# 1966 Corvette: Service Bulletin: Air Pump Noise - Air Injection Reactor System

**Subject:** Air Pump Noise - Air Injection Reactor System

Model and Year: 1966 Corvette

**Bulletin No:** TSB #66-62

# Date Code

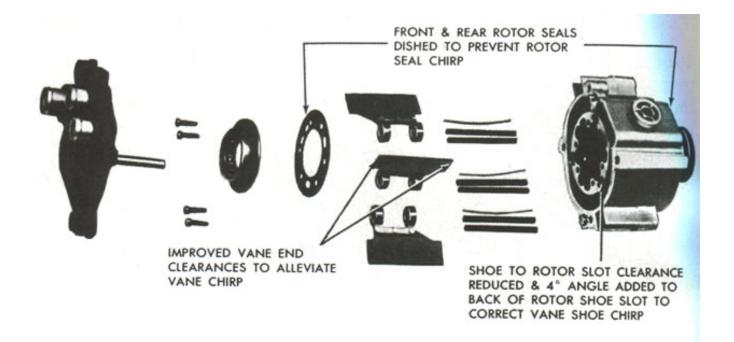
In production, beginning with date code 0126XX stamped on the pump housing, improvements have been incorporated as noted on page 2, to alleviate the above conditions.

If upon completion of the above, the "chirp" still persists, or if the "chirp" is heard at higher pump speeds, the entire pump assembly must be replaced with a pump having a date code of 0126XX or later. Control of pump service components is such that there is no identifying feature to indicate the latest improvements.
